Technical Bulletin

No: TB046 Rev: 0 Date: 31 Oct 2007

Description: Revise EMI / HXI Load Collar To Permit Full Freedom of Movement

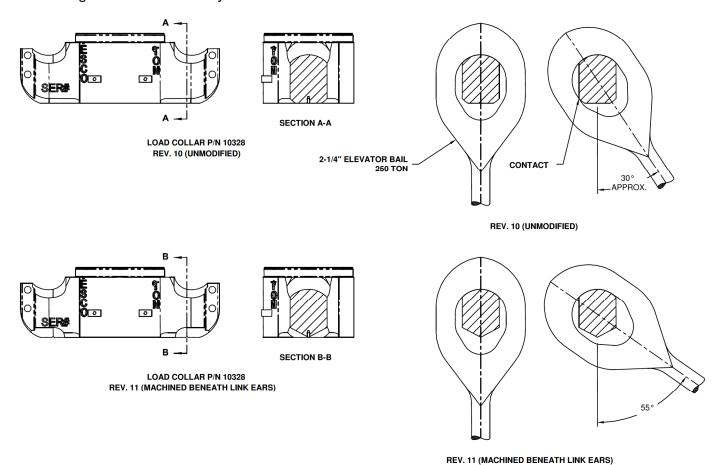
It had been observed in the field that some 250 Ton load collars for TESCO EMI and HXI top drives did not permit the full freedom of movement for the elevator link tilt. Investigation revealed that the cause of the interference was an excess of material beneath the load collar link ears. The correction was to machine away the excess material beneath the load collar link ears; however that created the secondary condition that it was possible for the link tilt cylinders to lift the elevator links until they impacted into the elevator link retainers. Therefore the elevator link retainers were also modified with additional clearance so as to eliminate the possibility of the elevator links ever impacting into the elevator link retainers.

If a customer raises a concern that the link tilt is binding on the load collar, confirm by testing the prescribed range of motion of the elevator links (up to 35° forward and up to 55° backward). If there is any interference that causes binding, perform the following remedial procedure. Perform the machining operation as documented in the latest version of the drawing for the load collar, TESCO p/n 10328; repeat the proof load testing of the corrected load collar; supply the latest version of the elevator link retainers, TESCO p/n 13169; re-install the load collar back onto the Top Drive; and test and confirm that the binding issue is now resolved.
